Office Action Summary

10/808,408

DETAILED ACTION

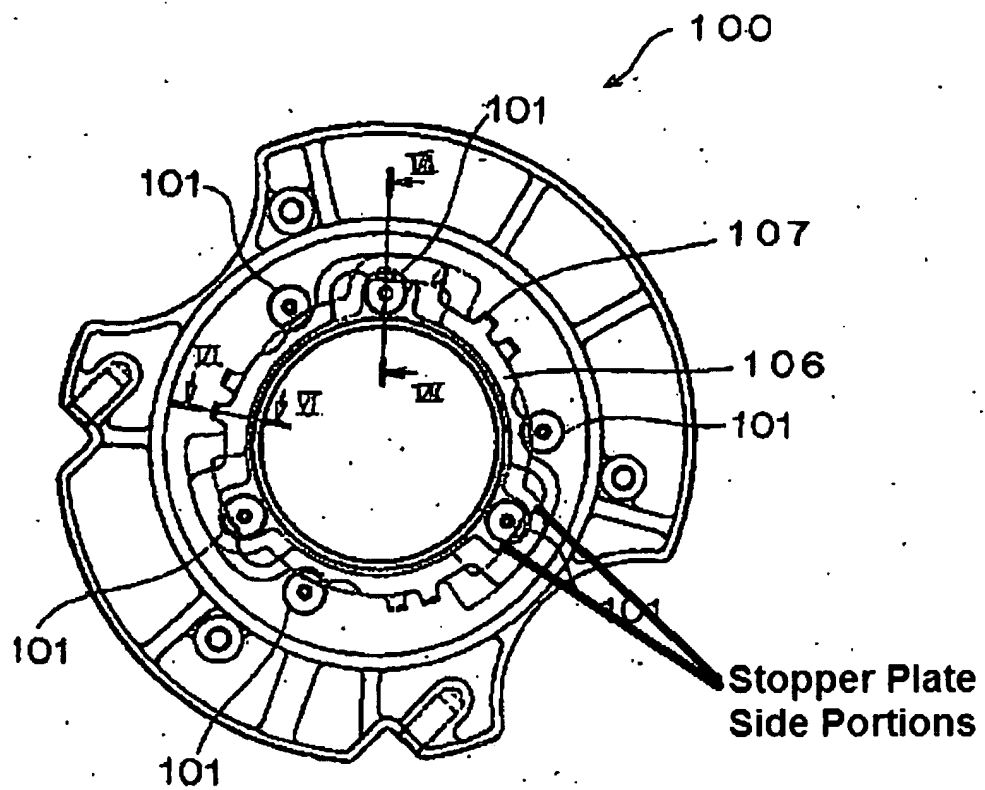
6. Claims 13-15 are rejected under 35 U.S.C. 102(b) as being anticipated by the prior art shown in Figs. 4-7 of the present invention.

Claim 13, the planetary gear structure shown discloses a carrier (100) having a cylindrical portion, a plurality of pinion shafts (101) mounted in the carrier (100), a stopper plate (106) with the projection portions of the plate (107) arranged between a pair of pinion shafts (101) to fix the pinion shafts (101) against revolution about their own axes.

Claim 14, this planetary gear structure shows the stopper plate (106) has side portions (labeled in the drawing below) extending along a radial direction and engaging one of the pinion shafts (101)

Claim 15, the planetary gear structure shown discloses a slit (103) on the pinion shafts (101) for engaging the stopper plate (106).
